## Product Change Notice (PCN)

**PCN Number:** PCN-0450265R-01

**Product(s) Affected:** SDS-J series (SDS-40J, SDS-50J, SDS-60J, SDS-70J, SDS-80J, SDD-130J)

## SDS-60J

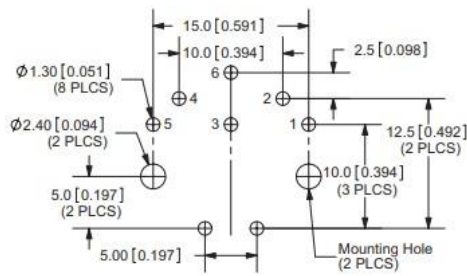
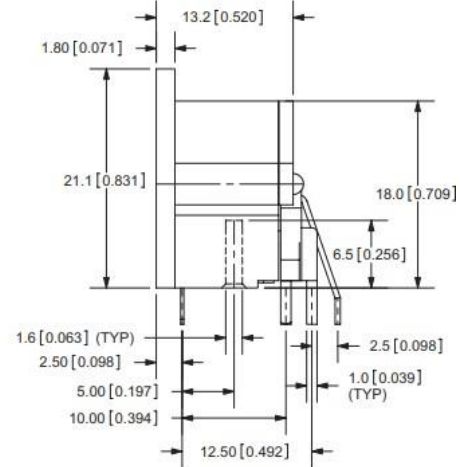
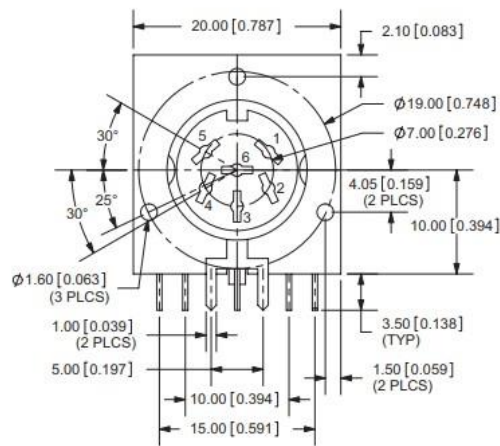
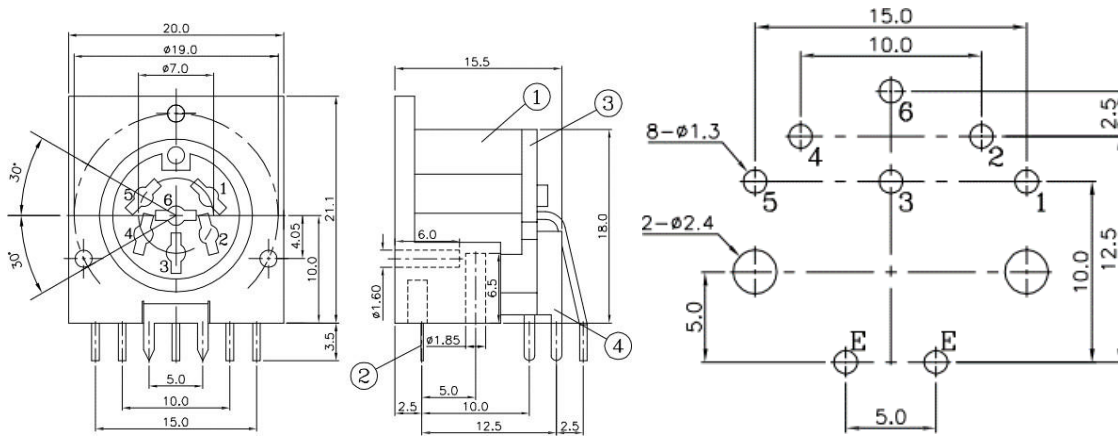
**Description of Change:** Dimensional changes and materials changes as shown below.

ITEM	DESCRIPTION	MATERIAL	PLATING/COLOR
1	housing	PBT (UL94V-0)	black
2	ground	phosphor bronze	copper/tin
3	cover	PF	yellow
4	terminal	phosphor bronze	copper/tin
